**SUBDIVISION, ZONING AMENDMENT,
PLANNED UNIT DEVELOPMENT &
SIDEWALK WAIVER STAFF REPORT**

Date: December 15, 2011

Sunset Point Subdivision

Subdivision approval to create one legal lot of record from
fifteen (17) legal lots of record; Planned Unit Development
Approval to allow shared access and parking between two
building sites; Rezoning from R-1, Single-Family
Residential District, B-1, Buffer Business District, and B-2,
Neighborhood Business District to B-2, Neighborhood
Business District to eliminate split zoning and allow the

SITE PLAN

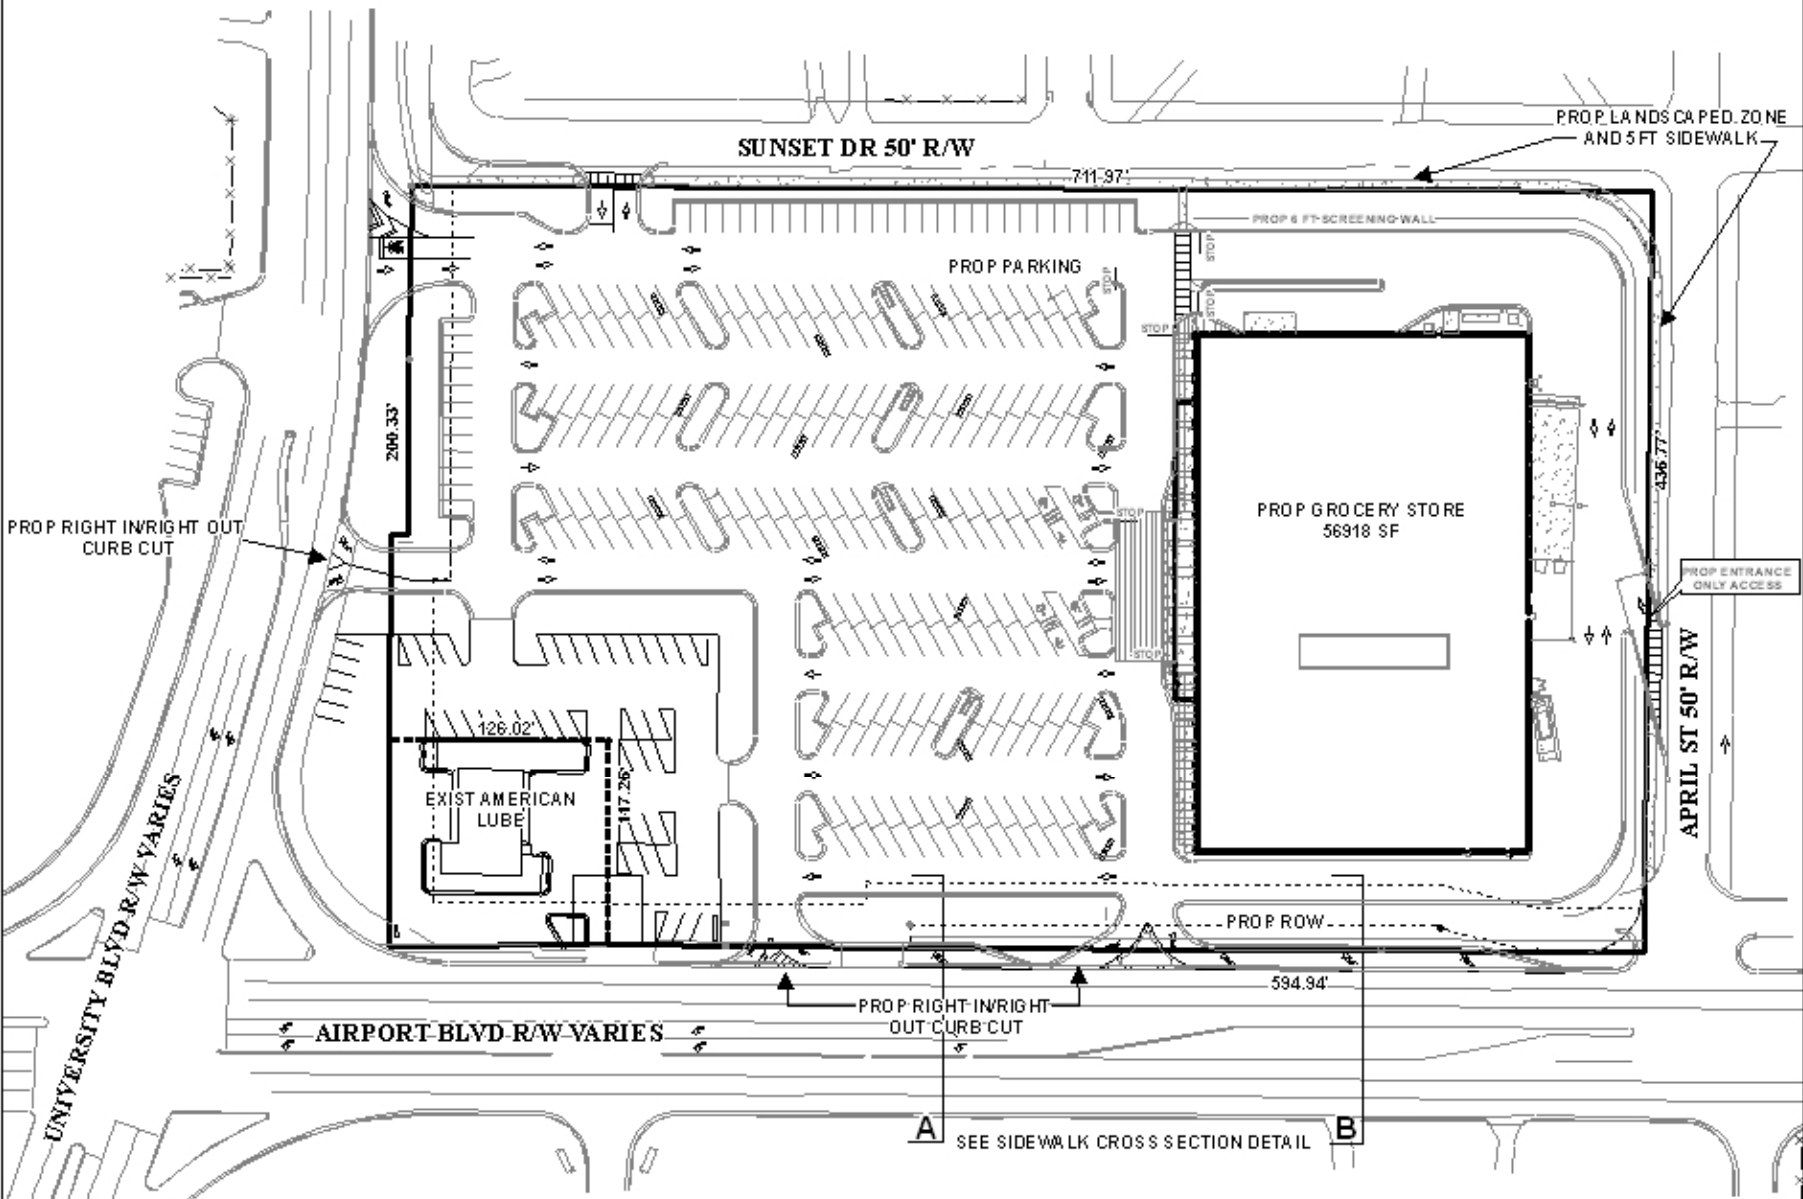
The site plan indicates approximately 278 parking spaces provided; as well as, information regarding the landscaping percentages and the number of required trees. While the Planned Unit

Buffer requirements as per Section 64-4.D.1. and the locations of all dumpsters with screening are illustrated on the site plan. As illustrated on the site plan, a 6-foot CMU wall is proposed, however, it is not specified if the wall will be stucco, split brick finish, or other design. Also, a planting at least 3-feet high at planting should be provided to break up the physical feature of the wall along Sunset Drive and April Street where the wall is illustrated on the site plan. Additionally, the site plan illustrates a “7.5-foot landscape zone” instead of the continuation of the 6-foot CMU wall along Sunset Drive where the building ends and the parking lot begins. However, the applicant does not specifically state what physically buffers the parking spaces from the residential dwellings; therefore, a solid hedgerow a minimum of 3-feet high at planting should be required. This physical hedgerow would provide a visual barrier from vehicle headlights shining into the residential properties.

Lighting on the site must comply with the requirements of Sections 64-4.A.2. and 64-6.A.3.c. of the Zoning Ordinance, and a note stating such should be placed on the revised PUD site plan, if approved.

It should be noted that the submitted site plan depicts the out parcel with the wrong dimensions; therefore, correction of these dimensions illustrating the out parcel as Lot A-1, Uniport Subdivision, Resubdivision of Lot 1 would be required (or it's inclusion in the subdivision).

- 1) revision of the site plan to show **ALL** improvements on the site including, but not limited to recommendations of the Traffic Impact Study and to include Traffic Engineering comments (Driveway number, size, location, and design to be approved by Traffic Engineering and conform to AASHTO standards. The western site driveway on Airport Blvd should be wide enough to allow for two 12' lanes. A raised island should be provided at this location if a minimum 50 ft² area is attainable. If the proposed ROW vacation of the service road in the vicinity of April Street is granted, the western corner radius of April Street at Airport Blvd will need to be adjusted. The edge of pavement along April Street should be extended straight to Airport Blvd and a new corner turning radius should be constructed. This can be done with curb and gutter depending on the drainage conditions in this area. The sidewalk illustrated in the plan as stopping at the northern existing edge of pavement for the service road would continue south to Airport Blvd.);

- 2) placement of a note stating, Lighting on the site must comply with the requirements of Sections 64-4.A.2. and 64-6.A.3.c. of the Zoning Ordinance;

- 3) correction of the out parcel outline illustrating the out parcel as Lot A-1, Uniport Subdivision, Resubdivision of Lot 1;
- 4) submission of two copies of the revised Planned Unit Development site plan to the Planning Section, Urban Development prior to adoption by the City Council;

- 5) provision of a solid hedgerow, 3-feet in height species to be approved by Urban Development along April Street and Sunset Drive, in conjunction with the 6-foot CMU wall illustrated on the site plan;
- 6) completion of rezoning and subdivision process prior to the issuance of permits; and
- 7) full compliance with all municipal codes and ordinances.

SIDEWALK CROSS SECTION DETAIL

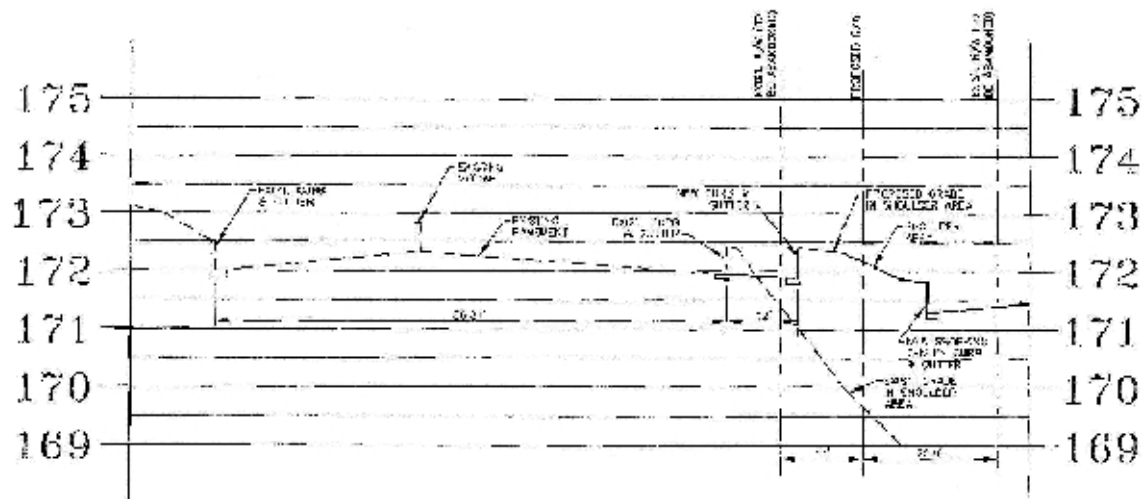
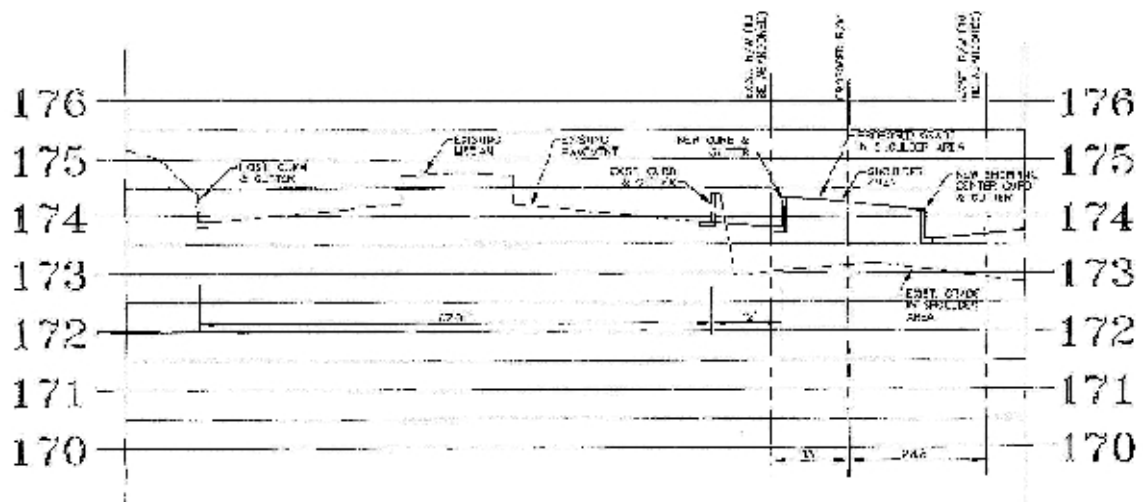
The applicant is also requesting the waiver of the sidewalk requirements along Airport Boulevard stating the sidewalk would be within a few feet of Airport Boulevard, the busiest street in south Alabama and that no such sidewalks are present West of I-65, and never will, due to the service roads. The applicant states the provision of sidewalks on all other sides of the development will provide for safe foot traffic. It should be noted that the site plan does not provide sidewalks along University Boulevard. Therefore, the site plan should be revised illustrating the placement of the sidewalk along University Boulevard or the sidewalk waiver heldover and amended to include University Boulevard.

It should be pointed out that staff has researched the presence of sidewalks along several sites along Airport Boulevard west of I-65 and have found several sites that have constructed sidewalks. Two examples are Marble Slab and the Rooms To Go sites. Another factor to consider providing sidewalks are the locations of WAVE bus stop Route 1 directly in front of the site on Airport Boulevard and WAVE Route 18 on University Boulevard, both may provide public transportation to customers to this site. Therefore, construction of sidewalks along ALL frontages would be beneficial to all parties. Traffic Engineering states that sidewalks should be provided along all street frontages and Engineering comments state there is sufficient room within the ROW, or partially within the property, for construction of a sidewalk.

Sidewalk Waiver: The sidewalk waiver is recommended for denial.
